PROTECTIVE IRRIGATION WORKS,  
RAJPUTANA.

INSPECTION NOTE

IRRIGATION WORKS AND PROJECTS,  
JHALAWAR STATE.

1905.

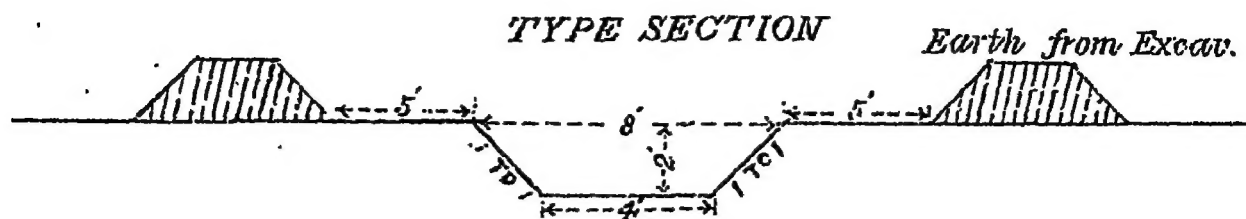
On the right bank 111 chains out of the 130 chains estimated for and set out have been partly excavated; and on the left bank 17 chains in extension of the 30 chains originally executed when the tank was constructed. In excavating the channels vertical sides have been given to save expense, and the earth excavated has been thrown up anyhow on either edge, even on sloping ground. This is a mistake, as in black soil the vertical sides will give way, and the earth on the edges is liable to fall in at any time. Except in rock and hard morrum, a slope of 1 to 1 should be given to the sides when constructing the channels, templates being constructed of the section of channel as a guide to the mates in charge.

On level ground, a berm of *at least* 5 ft. on either side should be given, and the earth excavated formed into a bank of proper section.

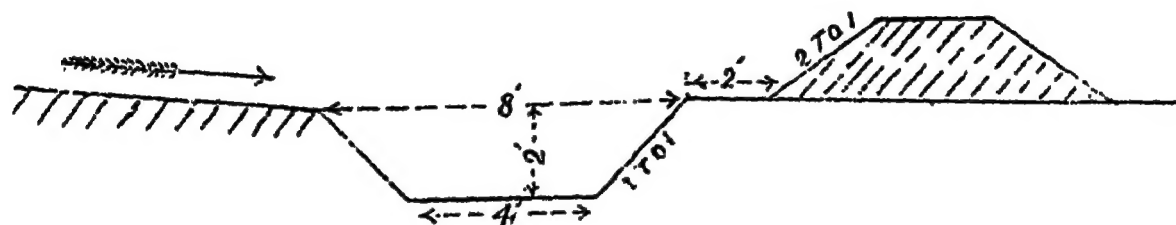
On side-long ground the earth excavated should be formed into a bank on the *lower side only*; and any surface drainage in the rains will then pass away down the channel.

The earth which has now been thrown up above the channel should be removed, otherwise in the rains it will all be washed back into the channel again, and cause trouble.

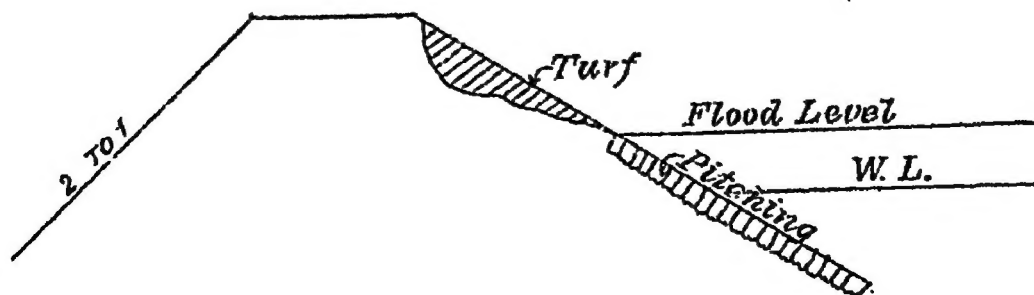
The dam would be extended on the north-west beyond the present weir till high ground is reached. At present the flood water damages the fields below at this end, and if the weir was altered I understand 25 bighas extra could be irrigated.

The front slope of dam, especially at south-east end, wants making up, as it is cut up by waves, etc.; and it should be turfed down to flood level and pitched below, to prevent a recurrence of this.

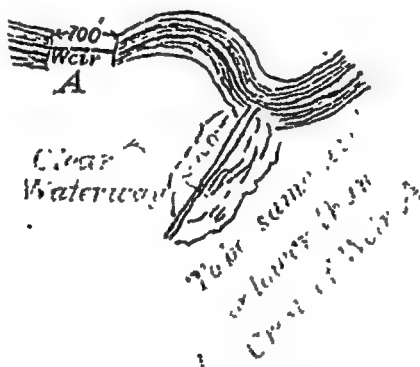
With regard to para. (8) the flood water has cut away the surface earth at the south weir down to rock, lowering the weir level to nearly 5 ft.

The water is cutting away the toe of the rear slope of the dam and a large area of good culturable land, in finding its way down to the nullah.

The Assistant Engineer proposes continuing the dam at this end on to high ground, and closing this weir altogether.

If the south weir is closed altogether—and I think it certainly should be done—levels must be taken to see that the ridge dividing the two catchments of the Mandliakheri tank is not higher than crest of the north weir. If it is, the ridge must be cut down to this level for 700 ft. in

**Semli Tank**  
(Site No. 10.)

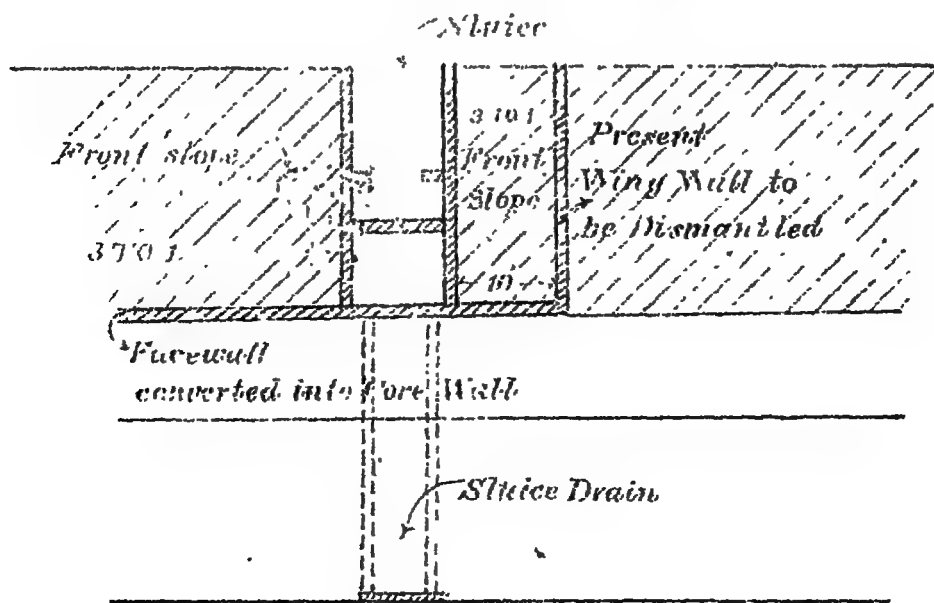
The tank has a catchment of 1 square mile, all hilly; capacity of 1.98 m. c.ft.; and about 40 bighas are irrigated. The villagers are most anxious for the weir and dam to be raised, as it overflows every year and there is plenty of land available for irrigation below.

With the hilly small catchment 20 per cent. of the average rainfall of 30 inches should certainly be available for storage, or 13 m.c.ft., sufficient for 130 acres or 325 bighas.

It would therefore seem well worth raising the weir and dam and building a sluice.

The Assistant Engineer should check the present capacity, and take contours of the basin to find the height the weir should be raised to give the proposed capacity. The maximum flood on 1 square mile is 825 cusecs, and this can be discharged by the 78 ft. weir with 2-ft. head, so crest of dam should be made 5 ft. above new weir level.

The babul trees should be removed and sold, and all roots removed before adding the new earth; and the face-wall might be converted into a core-wall, and to prevent any chance of water creeping round, the sluice should be fixed 10 ft. from the wing-wall, which should be dismantled as it is all cracked. The sketch shows what is suggested.

Motipura.  
(Site No. 11.)

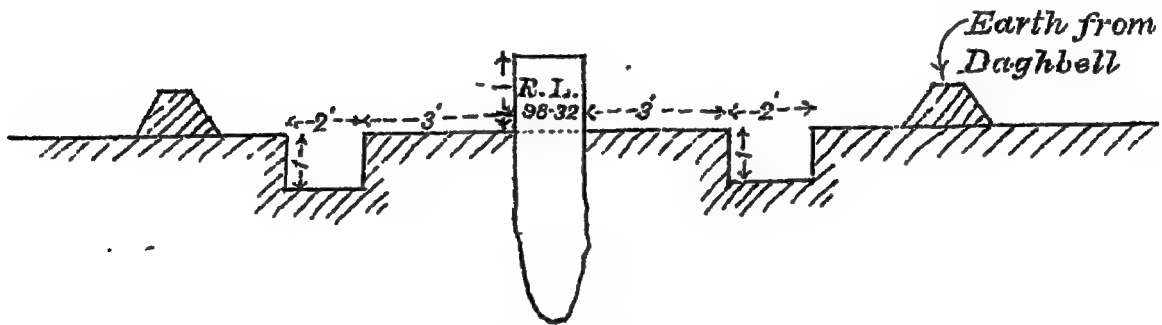
From topographical Survey the catchment is 7.5 square miles ; from this the maximum discharge (Dickens Formula) is 3.737 cusecs. and the length of weir required to discharge this with 2-ft. head is 375 ft.

The dam is proposed to be 6 ft. wide at top, with front slope  $2\frac{1}{2}$  to 1 and rear slope 2 to 1. Crest 5 ft. above weir level. The front slope should be made 3 to 1. The size of Sluice and Irrigation Channel required is not given, these should be worked out always by—

(a) Finding the discharge per second required to empty the tank in four months (Rabi Irrigation season) ;

(b) And as water is required simultaneously at first for Irrigation. the discharge required per second to give a first watering of 6 inches in 30 days of 12 hours' flow to the whole area for which there is sufficient water.

SECTION

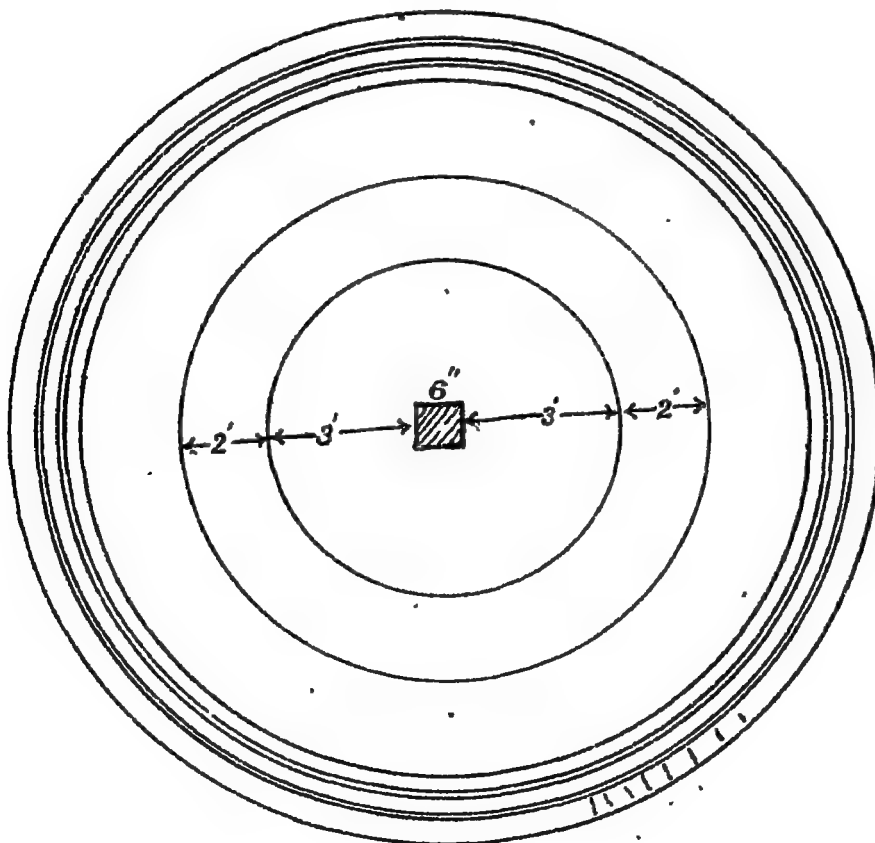
The line of the proposed dam was not daghballed out, nor were there any permanent bench marks. Wherever

- (a) The line of dam clearly daghbelled from end to end, 1 ft. wide and 1 ft. deep.
- (b) Permanent bench marks erected, cut out of the rock in river beds or where rock occurs, along the line of dam, showing the bed level of nullah, and every 5 ft. rise, also at any point where the line changes. Also at ends of the base line and cross-section lines of survey.

These bench marks should be stones set on edge, embedded  $1\frac{1}{2}$  in the ground, with a circular daghbell all round as per sketch, the number and reduced level, corresponding with Field Book, being marked on the stone.

Ratanpura  
(Site No. 19).

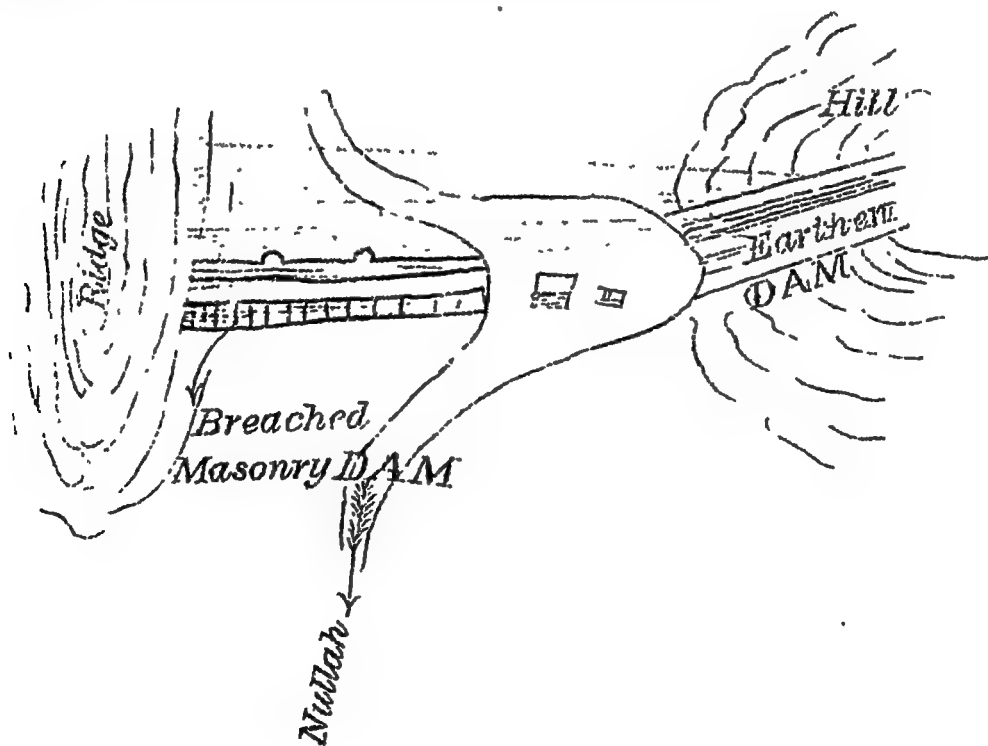
But the catchment area has been over estimated, as from the Topographical Survey Map it is only half a square mile.

This reduces the water available for storage to 7 m. c. ft. even if we allow 20 per cent. of rainfall, as the catchment is hilly. This will therefore reduce the capacity of the tank, and the surveys should be carefully checked and the water-spread and capacity at each 5 ft. contour carefully worked out.

The weir level should be kept at the lowest point of the ridge towards Ratanpura village, and the water allowed to spill over here, even should this give a greater capacity than required; the maximum discharge on the half square mile catchment is 490 cusecs, and as this gap in the ridge is about 400 ft. long the water is not likely to cut it away. The line proposed by the Assistant Engineer for the earthen dam across the nullah may be accepted, but care must be taken that the new dam is entirely separated from the old dam; and the space in rear between should be filled up to the top of the masonry wall to prevent a pool of water being held up between, which would damage the dam.

The line of dam was not daghbelled out, nor were there any permanent bench marks, not even one on the masonry dam, so that it is impossible to check the surveys made by Sub-overseer Muntaz Ali. The directions given in para. 12 should always be carried out.

The Plans made are difficult to estimate from, as the cross sections are drawn to far too small a scale.

They should always be drawn to a natural scale 10 ft. = 1 inch. Directions on this point and a printed copy of one of the projects prepared in this office have been given to the Assistant Engineer as a guide for the future.
